Service Bulletin

RRP Service Bulletin No: RRP SB387

Title: Oil Cooler Suppressor Kit

Product Series: Advanced Tie Plate Inserter [ATPI]

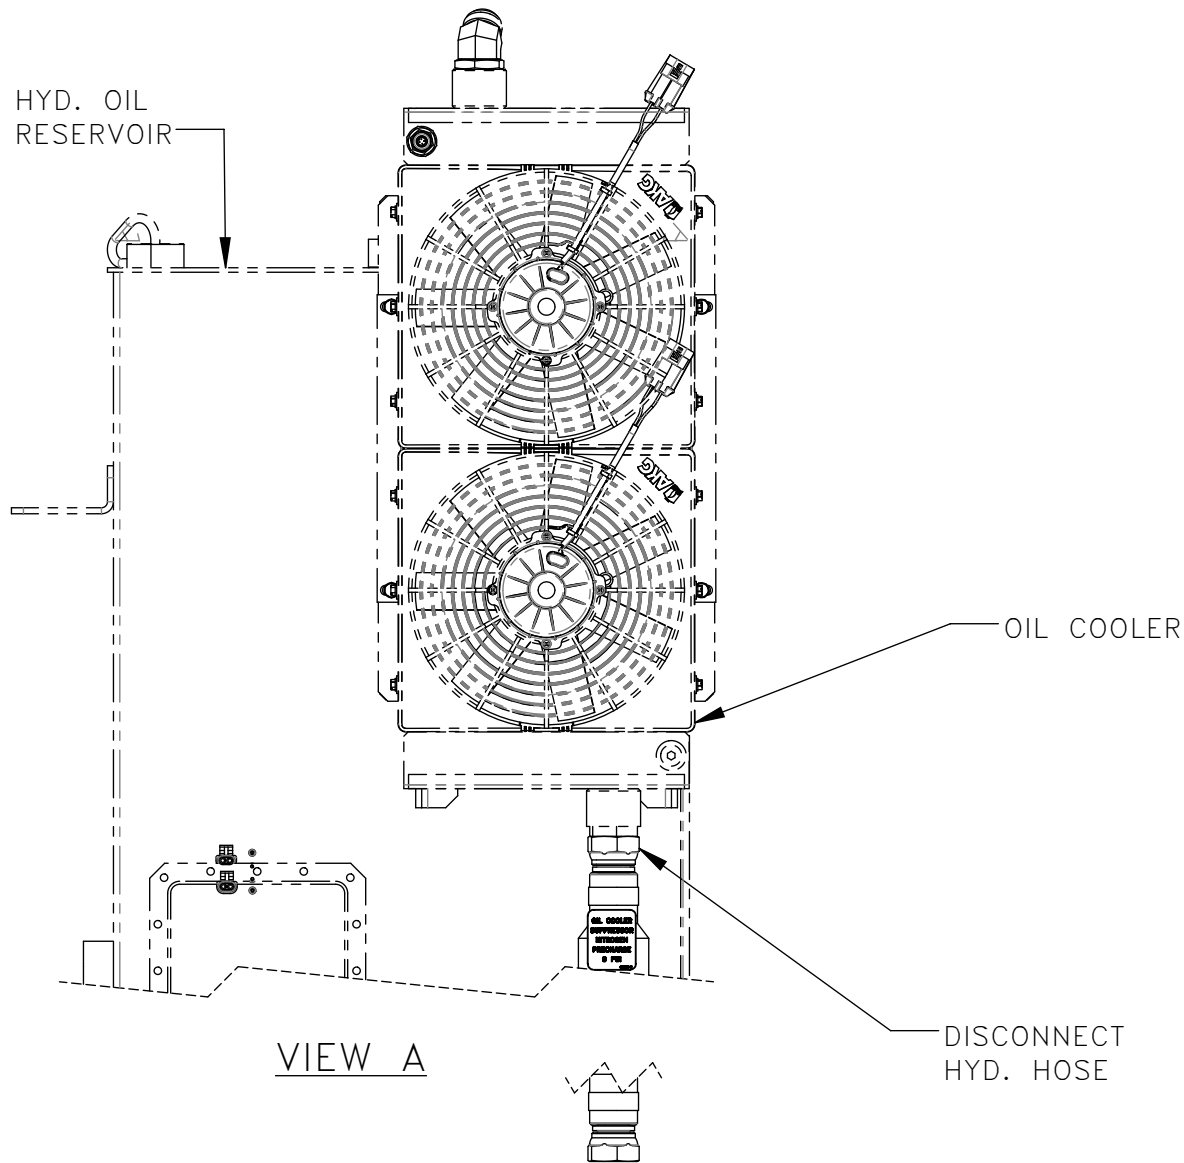
Action: Install the 793133 Oil Cooler Suppressor Kit. See instructions and parts list on next page.

NO.	QTY	DESCRIPTION	PART NO.
1	1	ELBOW, 90°: #20 JIC(M) X #20 SAE(M)	463396
2	1	ADAPTER, #20 JIC(F) X #20 SAE(M)	463549
3	1	SUPPRESSOR, HYDRAULIC	472292
4	1	DECAL, NITROGEN PRECHARGE 0 PSI	477018
5	1	INSTRUCTIONS, ATPI OIL COOLER SUPPRESSOR KIT	800379

THESE INSTRUCTIONS ARE FOR KIT 793133

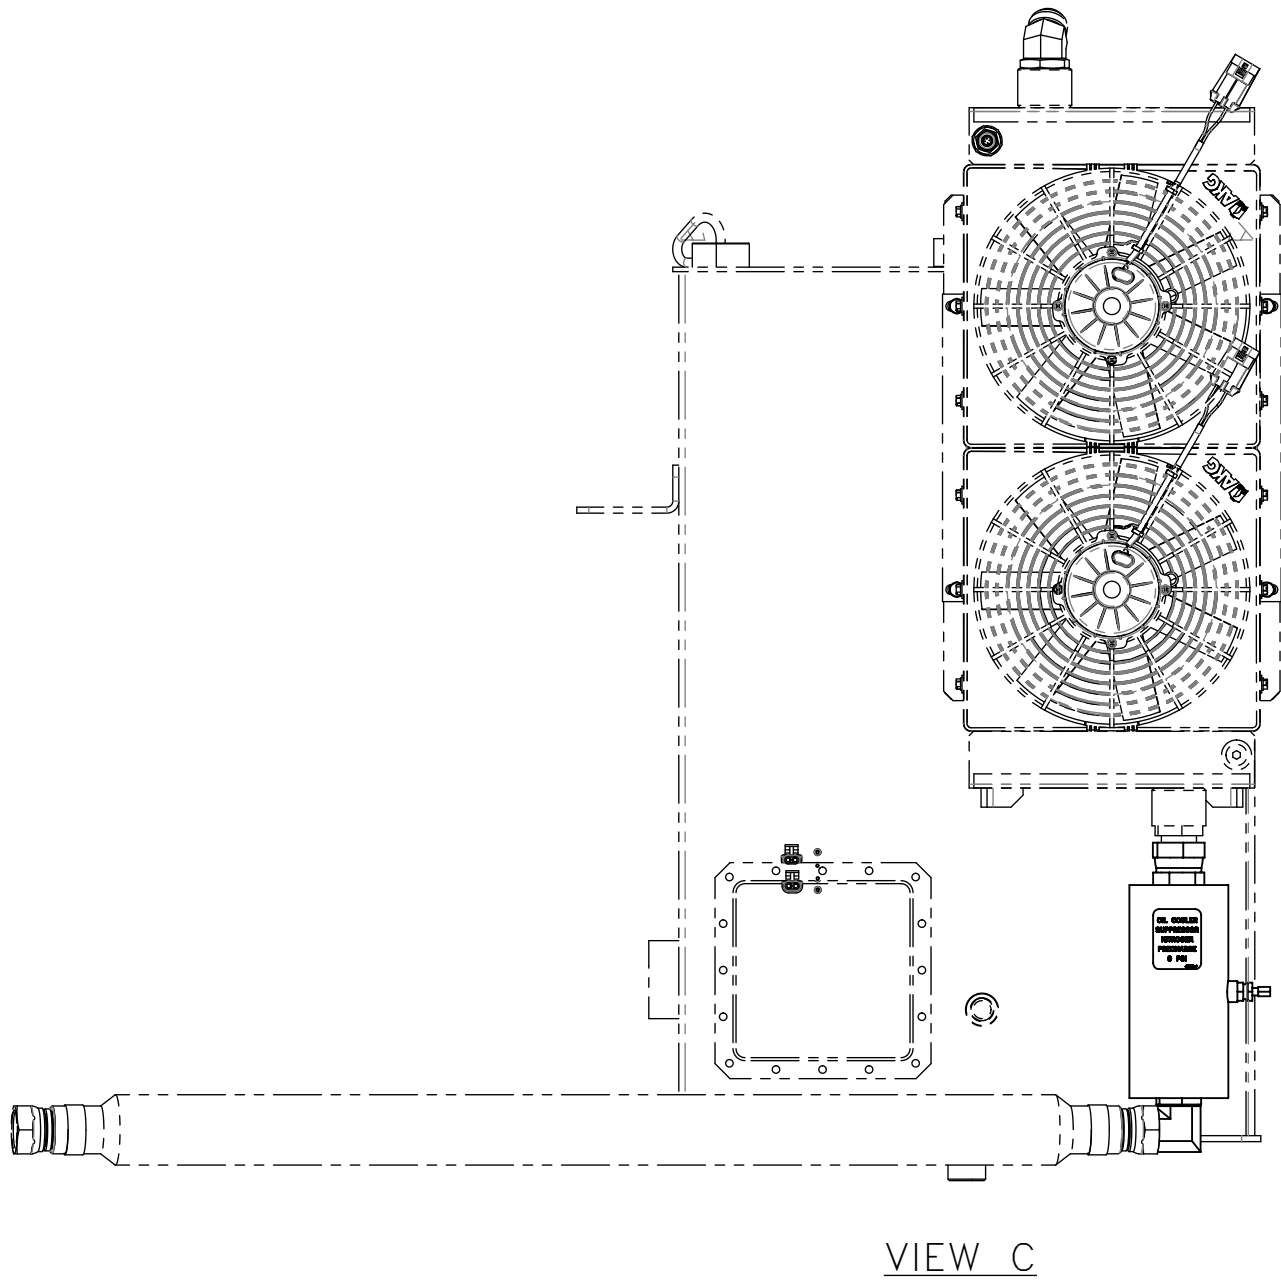
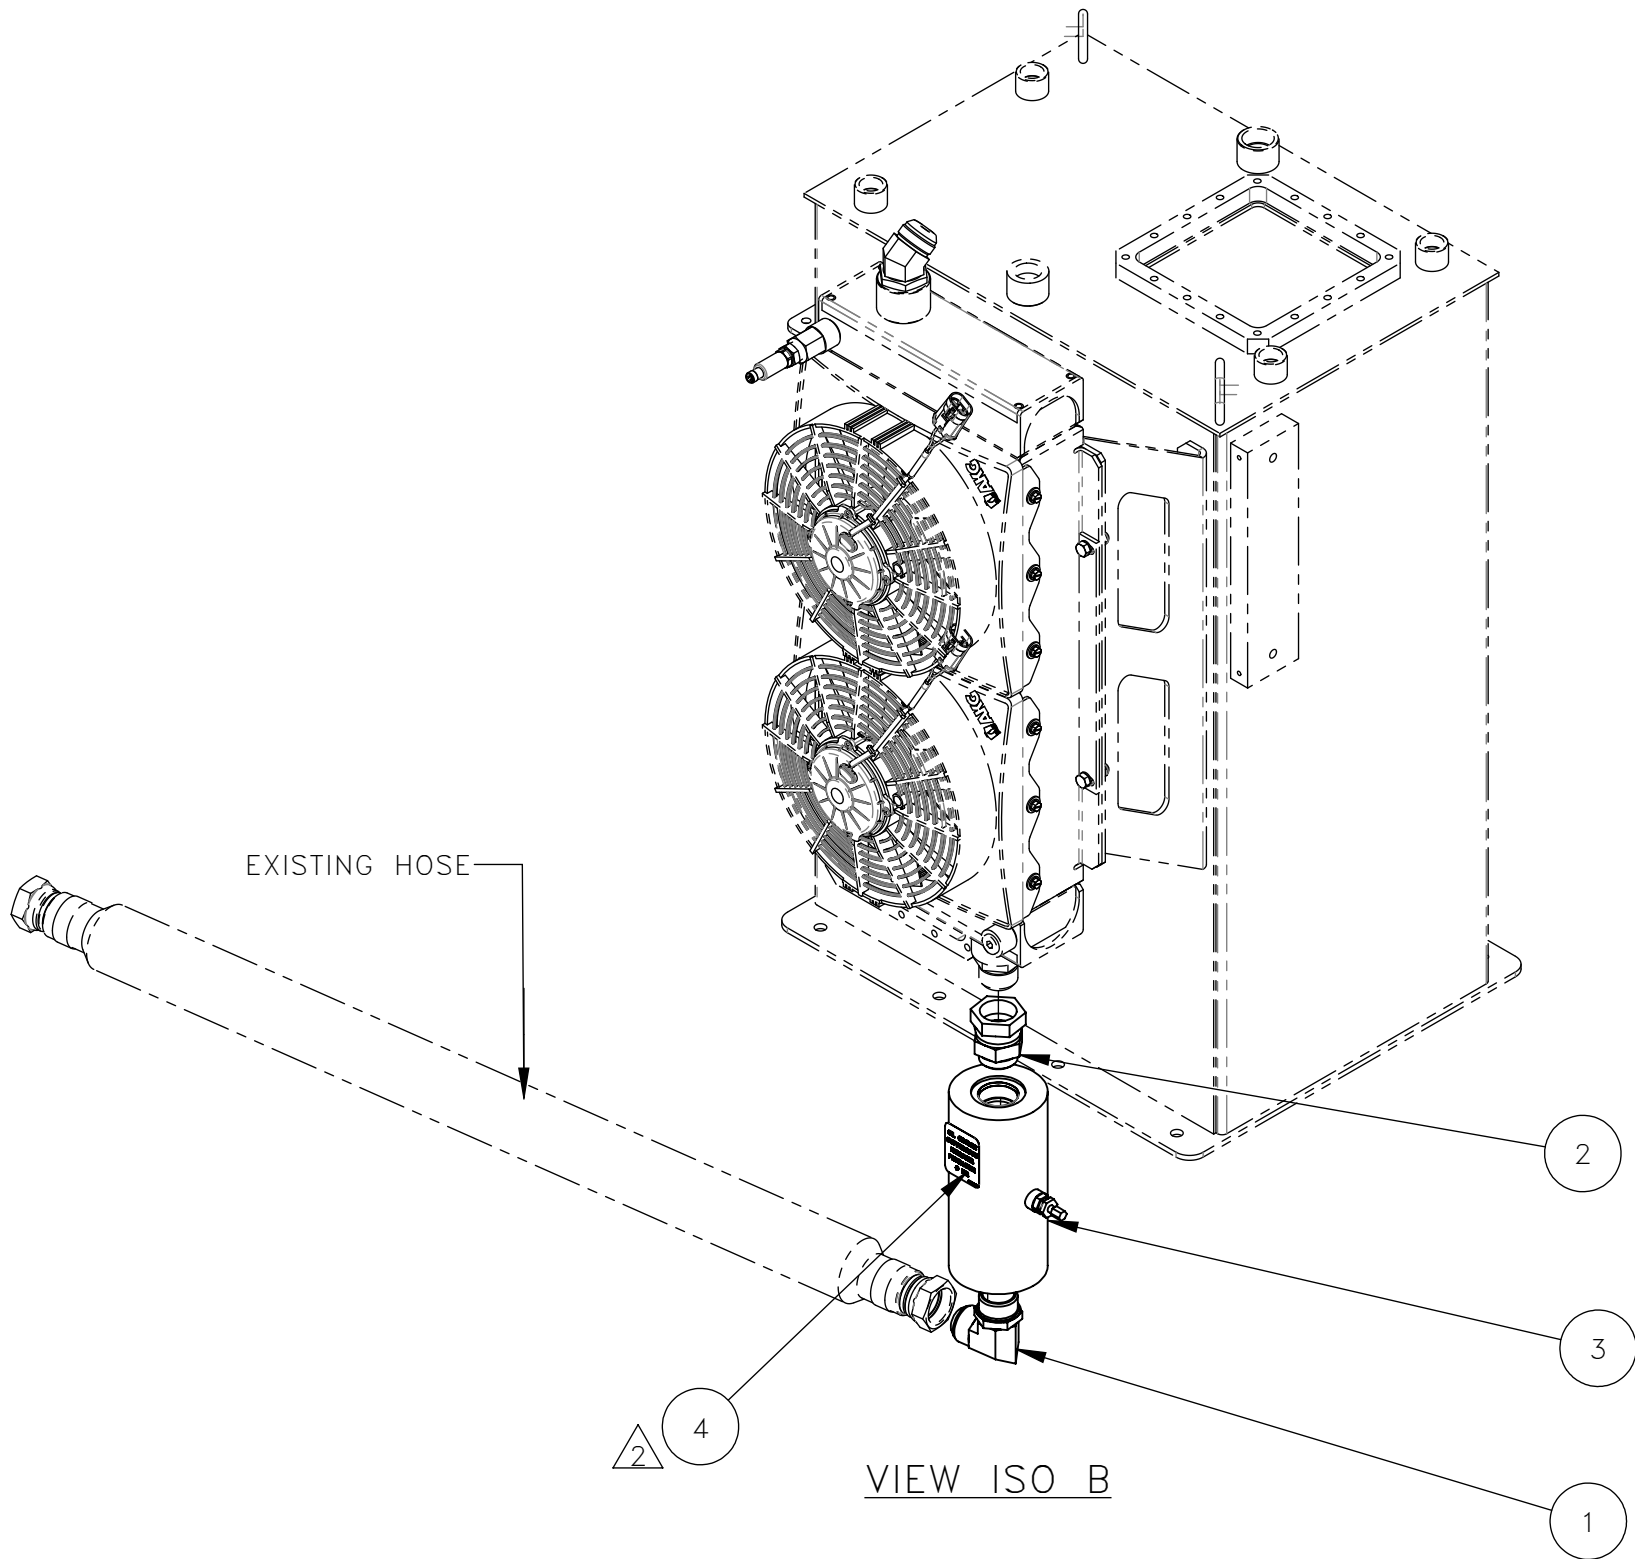
- REMOVAL:
1. POWER OFF MACHINE AND TAG OUT BEFORE PERFORMING CONVERSION
 2. DISCONNECT HYD. HOSE FROM THE BOTTOM OF OIL COOLER (SEE VIEW A).
- INSTALLATION:
1. ADD ADAPTER, SUPPRESSOR AND ELBOW AS SHOWN (SEE ISO VIEW B).
 2. REATTACH HYD. HOSE TO ELBOW (SEE VIEW C).
 3. ADD DECAL TO THE SUPPRESSOR, PLACE TO BE SEEN. (SEE ISO VIEW B).
